HISTORIC LANDMARK COMMISSION STAFF REPORT

Shumway Rear Addition Case PLNHLC2010-00628 1032 East 1st Avenue October 6, 2010

WEST ELEVATION
Scale 1/4" = 1'-0"

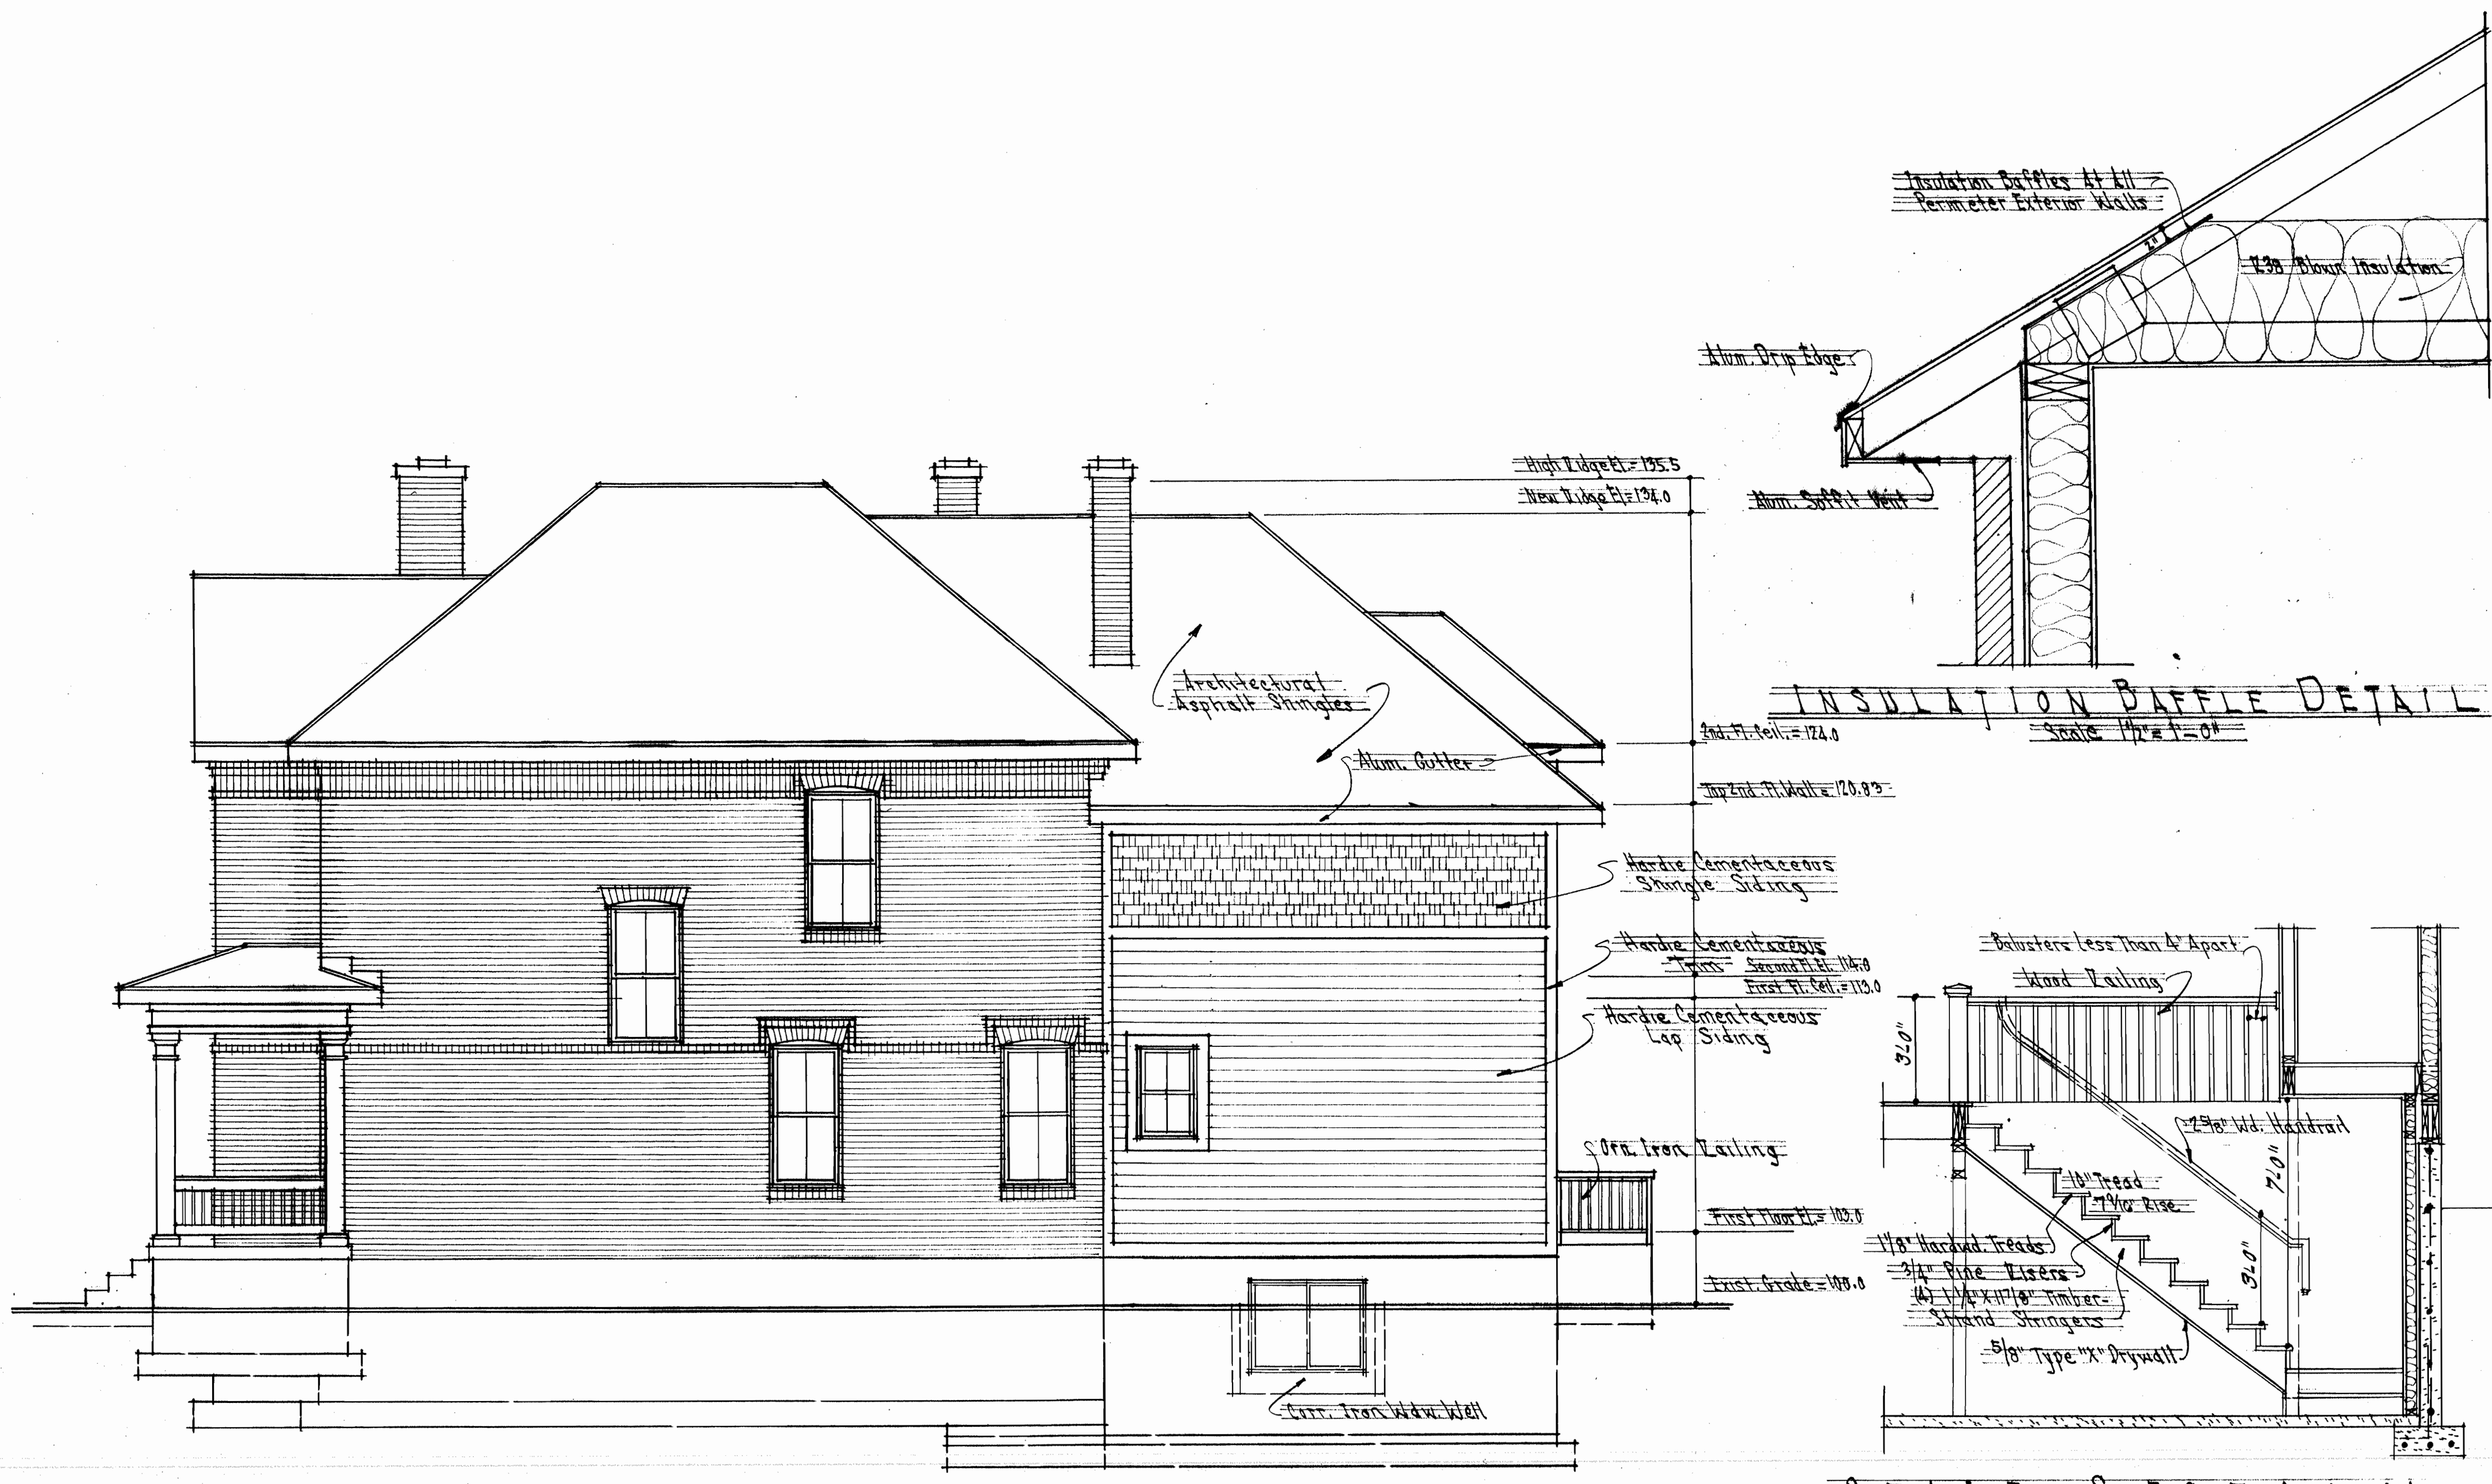
To achieve a second story addition, the proposed alteration to the house would raise the roof and wall height at the rear of the building and alter the design of the existing side gables. These alterations are not consistent with the characteristic scale and massing of this house type, and the variety of building forms distinctive of this area of the neighborhood. The proposed addition is not consistent with the design guidelines mentioned above which are intended to ensure that the historic character of the property is not adversely affected. The mass and scale of the building and arrangement of roof forms would be altered such that the historical and architectural integrity of the property and district will not be respected.

Analysis: The proposed rear alterations, if removed, the essential form and integrity of the structure could not easily be restored to its original appearance. The new second story addition could be considered compatible with the size, scale, massing and architectural detailing of the existing building based on the analysis in this staff report, however, as proposed it would blend with the original structure and would not be clearly distinguishable from the old.

SOUTH ELEVATION
Scale 1/4" = 1'-0"

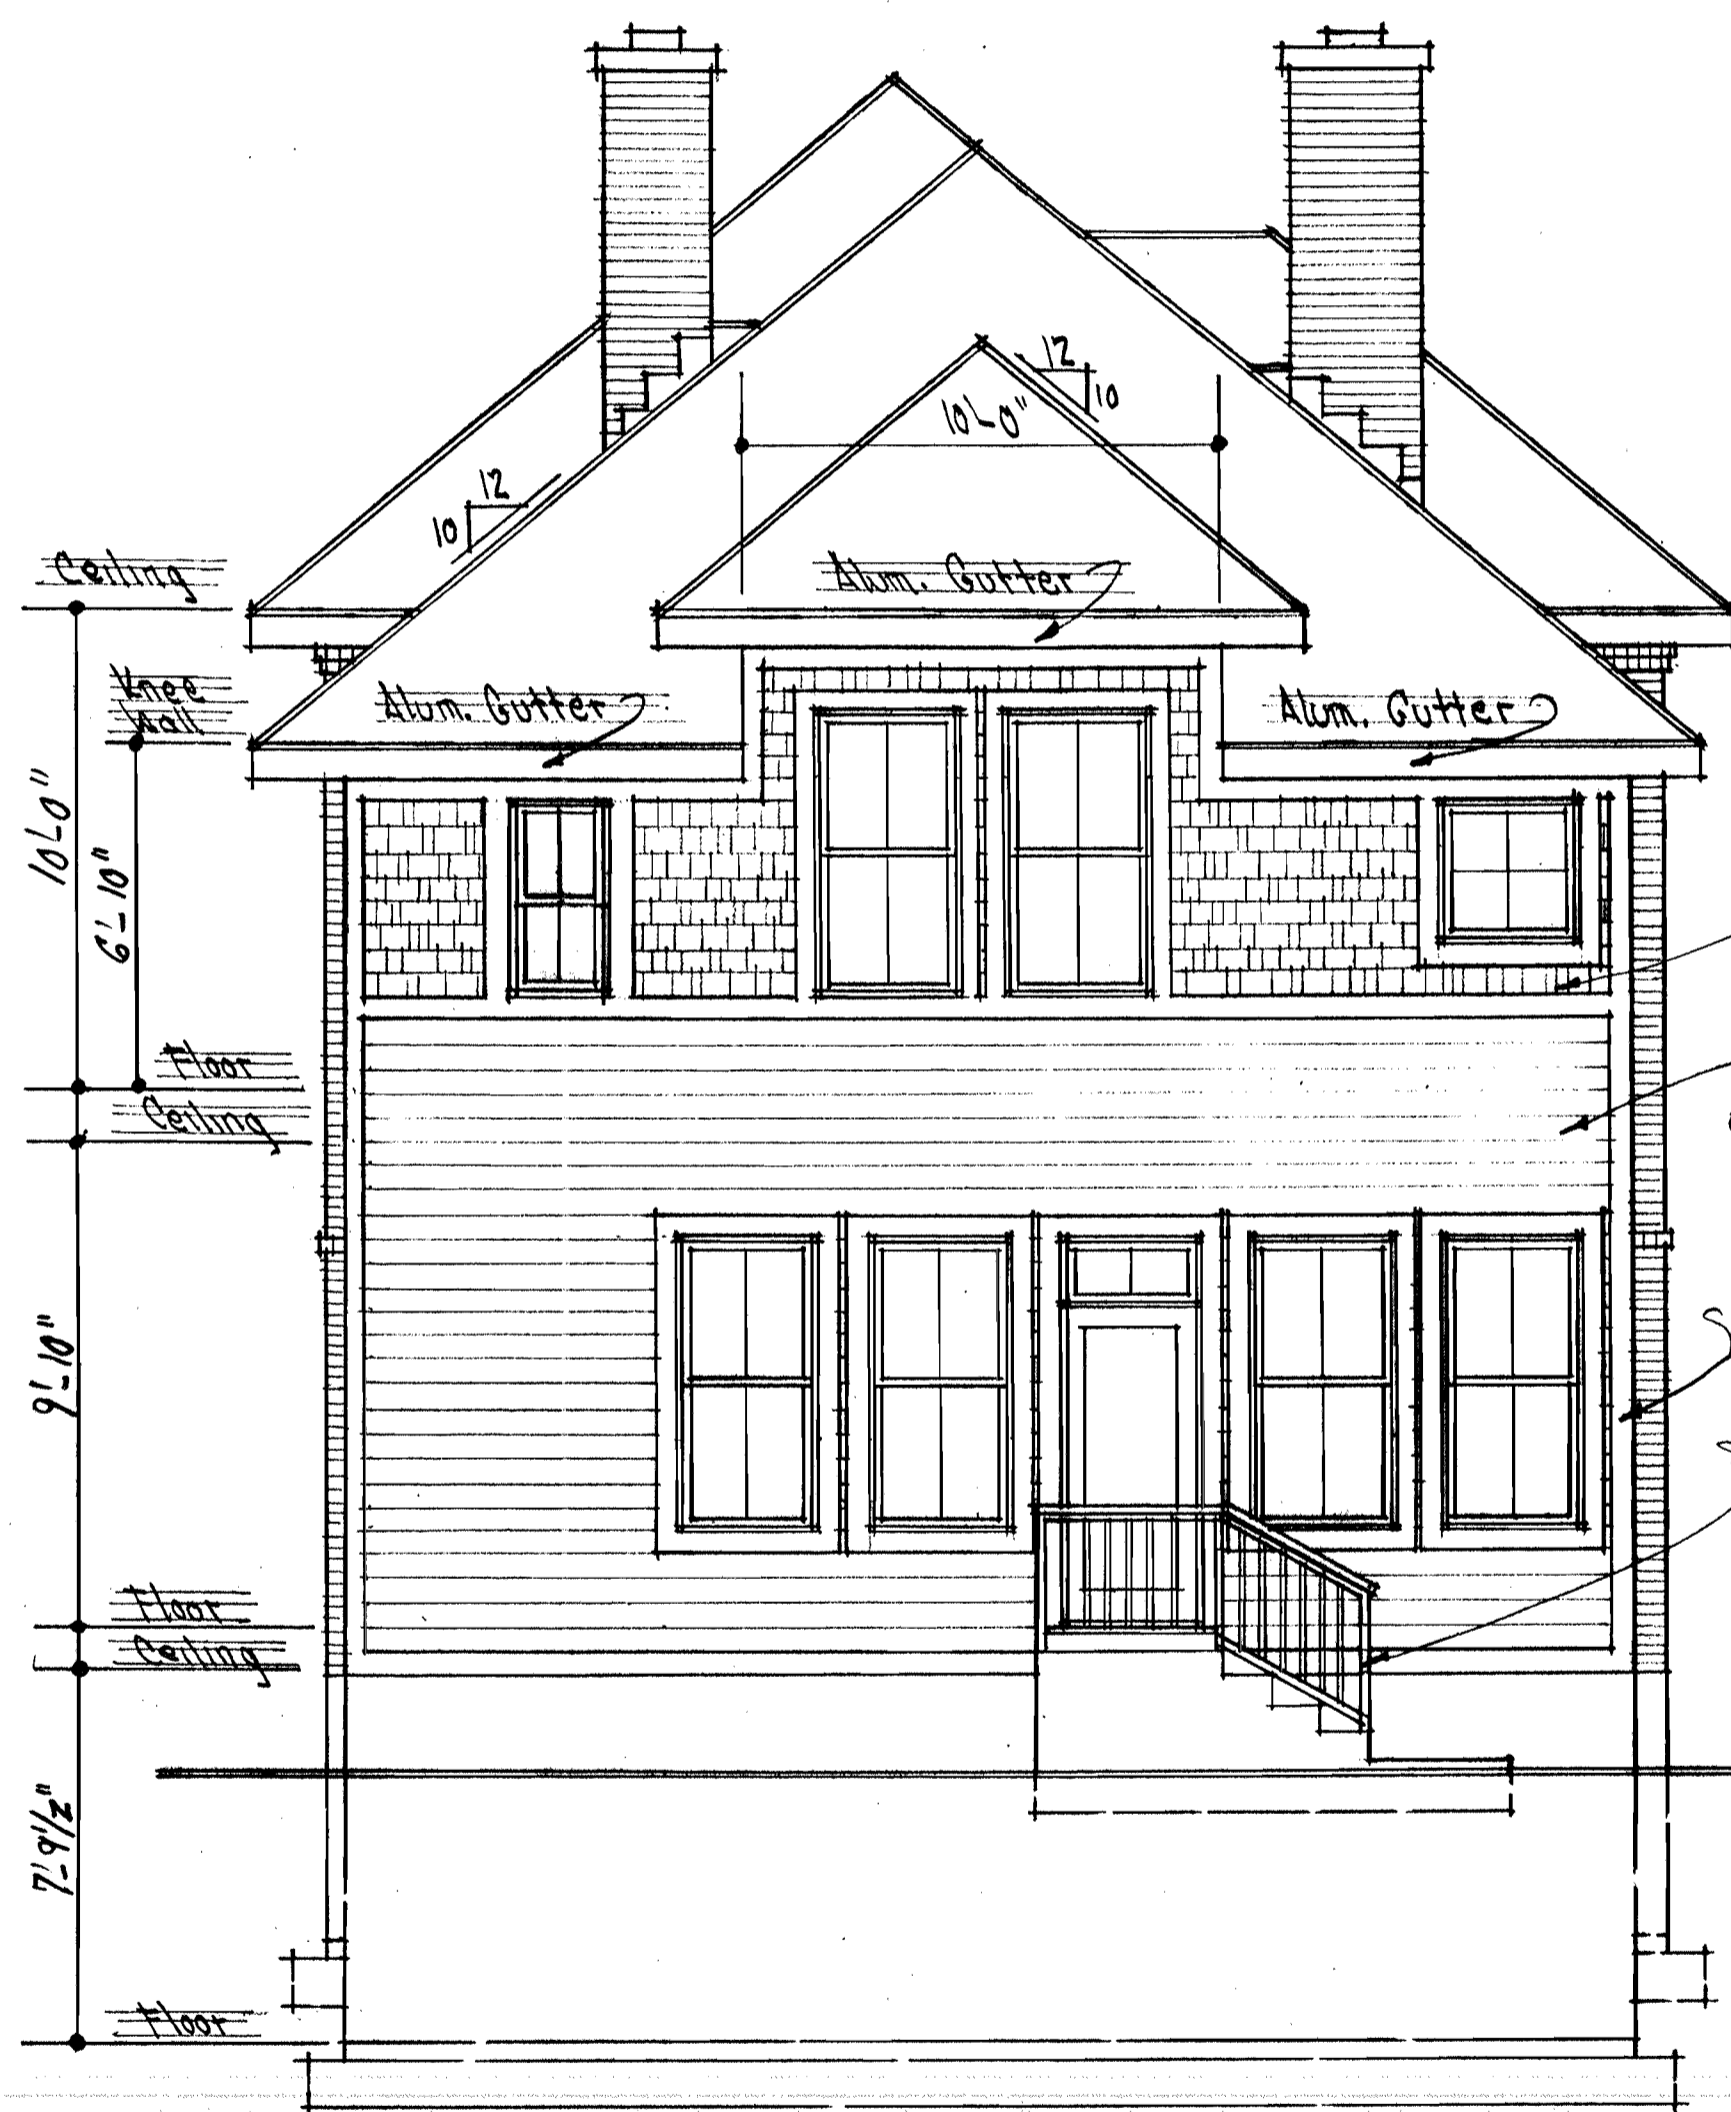
Finding for Standards 2 and 5: Staff concludes that the rear addition is not compatible with the historic fabric and character-defining features of the original house form. The proposal is clearly a recognizable addition but does not preserve nor retains character-defining features of the house and compromises the historical and architectural integrity of the property, neighborhood and district.

Analysis: The proposed in line rear addition would follow the setbacks of the historic building. However, the existing roof modification, the new lowered roof and wall height of the second story, would not be clearly distinguishable as new construction from the historic building. The proposed addition and materials, seek to imitate the existing materials but the subtle change will not be clearly distinguishable from old to new construction.

Finding: Staff finds that the proposed addition fails to comply with design standards 8.1, 8.2, 8.5, and 8.12 as it modifies the roofline and erases the rear of the unaltered original building form. The proposed addition departs from the original building form and does not keep visually compatibility with earlier features
